2023FA04
October 18, 2023
Product Code(s): 65
Page 1 of 3

SUBJECT: Output Shaft Yoke/Flange Retaining Bolt Torque Specification Increase

MODELS AFFECTED: B3400 R xFE™, B400 R

Figure 1.

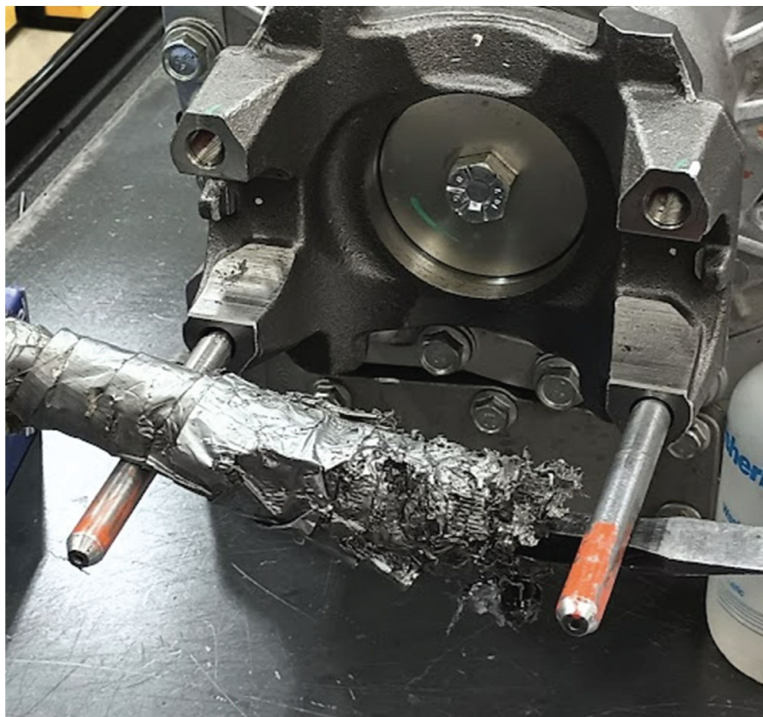
3. After disconnecting driveline from transmission output yoke, secure transmission end of drive shaft away from output yoke. U-joint straps and bolts CANNOT be reused and must be discarded, and replaced with new hardware kit.
4. Using a pry bar or yoke holding fixture, secure the yoke so it will not rotate.
 - Make sure not to damage yoke u-joint cavity or other machined surfaces (refer to [Figure 1](#)).

5. **Torque output shaft yoke/flange retaining bolt P/N 29535219 to new specification; 130 N·m (95 lb ft).**
6. Clean original paint mark and reapply paint mark to the output retaining plate and output yoke bolt with one continuous mark.
7. Reinstall driveline and secure u-joint to transmission output yoke with new straps and bolts from hardware kit.
 - Follow manufacturer's torque procedure and specifications. Refer to [Figure 2](#).
 - Prior to lowering bus from lift, mark transmission nameplate with paint pen to indicate output shaft yoke/flange retaining bolt torque has been verified.
